SUBJECT: Application for amends to licenses DPR-80 & DPR-82, revising
TS 6.8.4f, to control operation of containment polar cranes
in jet impingement zones.

PG&E Letter DCL-98-113

Docket No. 50-275, OL-DPR-80
Docket No. 50-323, OL-DPR-82
Diablo Canyon Units 1 and 2
License Amendment Request 98-07
Revise Technical Specification 6.8.4f., "Containment Polar and Turbine Building Cranes"

**REVISE TECHNICAL SPECIFICATION 6.8.4f.,
"CONTAINMENT POLAR AND TURBINE BUILDING CRANES"**

Figure 2 -
CFCU Load Path Through Jet Impingement Zones

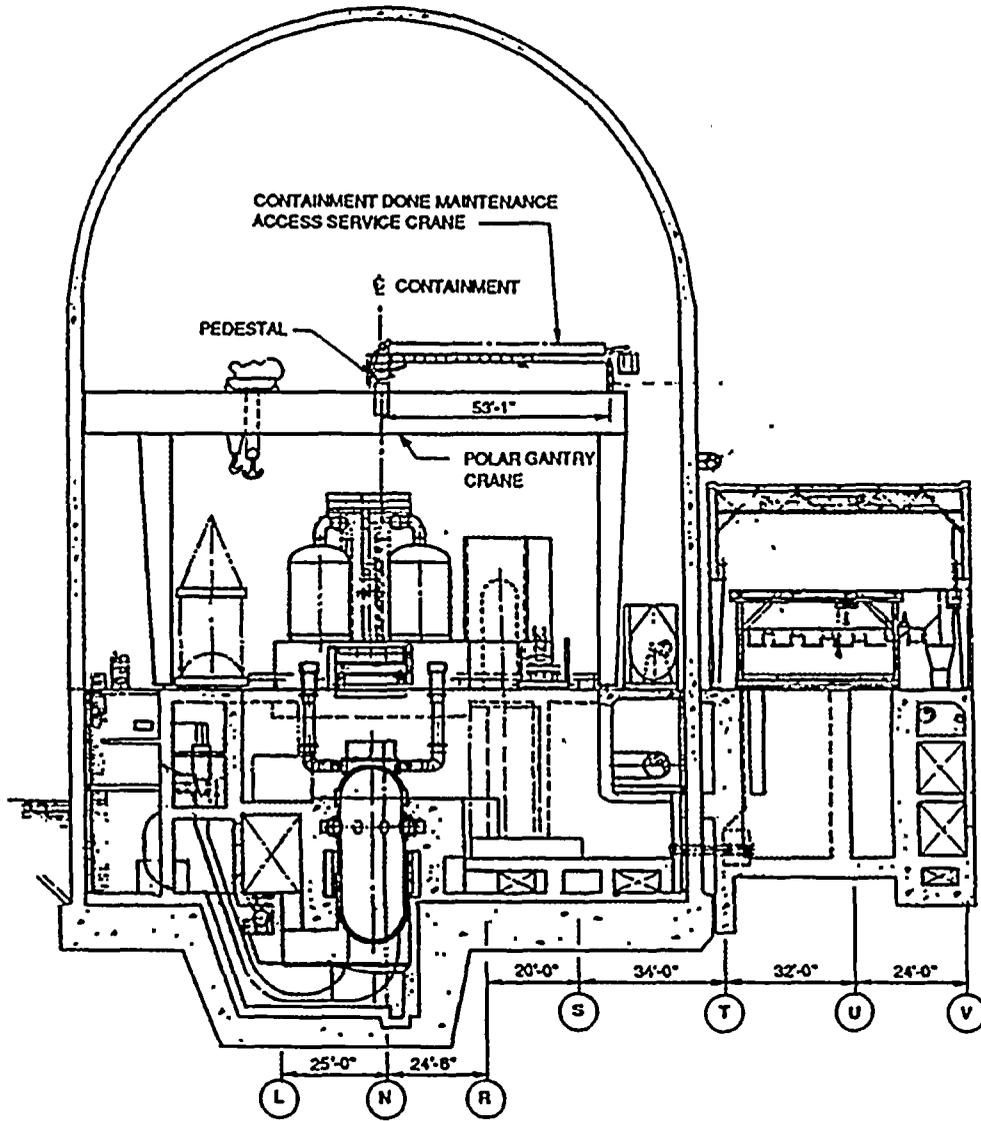
the polar crane is not qualified for combined seismic and jet impingement loads, it is parked outside the jet impingement zones shown on Figure 2, "CFCU Load Path Through Jet Impingement Zones." This limitation is incorporated into the administrative controls for polar crane operation.

In the hypothetical work plan for the CFCU motor move, the load path using the polar crane is illustrated in Figure 2, "CFCU Load Path Through Jet Impingement Zones." The major work activities include:

1. Move the polar crane through the jet impingement zones to align the auxiliary hook over the CFCU eye bolts.
2. Rig the CFCU motor for lifting.
3. Lift the CFCU motor complying with heavy load evaluation lift height restrictions and move it to its cart.
4. Move the CFCU motor and cart through the jet impingement zones to the personnel hatch area.
5. Move the CFCU motor and cart out of containment.
